25 March 2022

AQUATIC ASSESSMENT OPINION OF THE PROPOSED LAYOUT AMENDMENT FOR THE WIND GARDEN WIND FARM

Figure 1: The results of the aquatic habitat delineation against the initial development layout

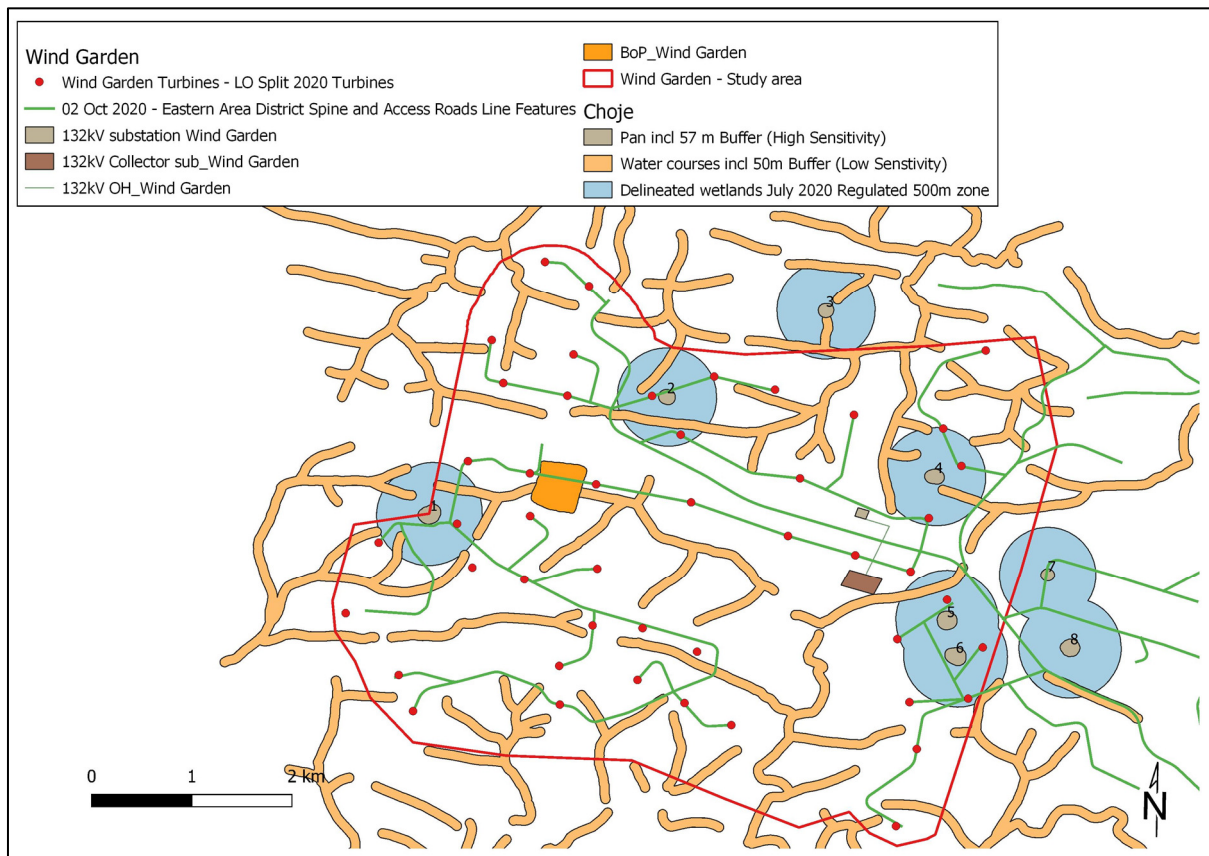
EnviroSci (Pty) Ltd was appointed to review the proposed amendments to the project layout against that which was assessed in the aquatic impact assessment submitted in 2021. Figure 1 indicates the result of the aquatic assessment, where various sensitivities were indicated to the applicant, and where possible / feasible these aquatic habitats have been avoided (Figure 2).

Figure 2: The various sensitivity layers against the optimised wind farm layout

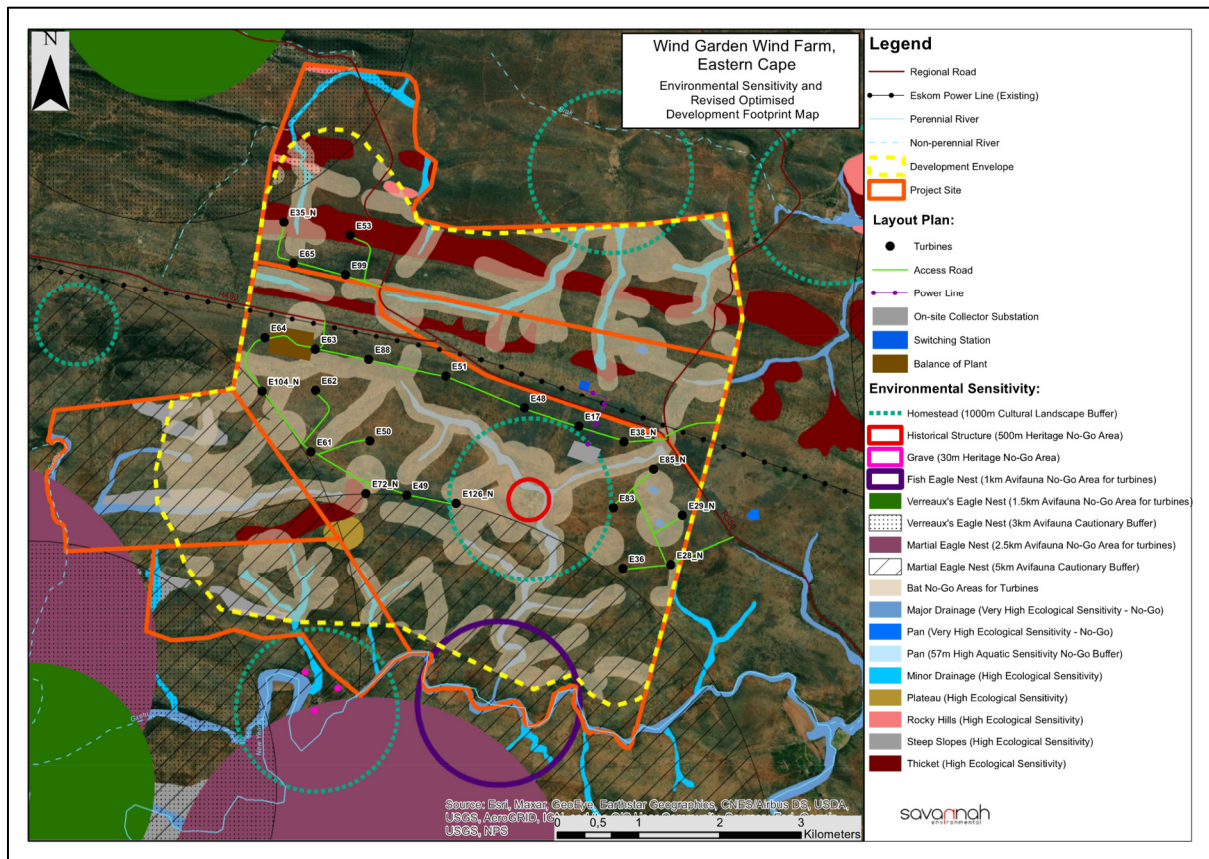
In order to address the outstanding concerns raised by I&APs the applicant has now optimised the wind farm layout, which includes a reduction in the number of wind turbines and a consolidation of the access road network (Figure 2). Furthermore, current best available technology is a turbine with a lower hub height than initially applied for (i.e. reduced from 120m to 115m). Given that the change in hub height does not impact on the turbine footprint, this change does not affect the aquatic environment impacts.

Therefore, the most significant amendment would be a **decrease in the overall footprint** of the facility, which in turn has led to a reduction in the overall impact on the aquatic environment (Figure 2). Of particular importance is now the avoidance of several of the Pan buffers, as well as the reduction in the number of watercourse crossings required. The internal access roads to Turbine E29_N and between E61 and E104_N (Figure 2) is still of concern due to their proximity to pans as highlighted in the original assessment.

In conclusion, the potential impact of the proposed amended layout on the aquatic environment will remain unchanged from the original impact assessment as the proposed mitigations (avoidance of High Sensitivity Environments through revision of the layout) have been integrated into the optimised layout (Figure 2).

Thus, based on the findings of this study, no objection to the authorisation of any of the proposed layout amendments, assuming that all remaining mitigations are carried out. Similarly, in the assessment of potential cumulative impacts, no additional impacts or changes to the previously assessed impacts would be required due to the proposed amendments. This is however based all on the assumption that the tow internal access road areas are again ground-truthed and that micro-siting ensures that the delineated aquatic zones are in fact avoided by the final road footprint
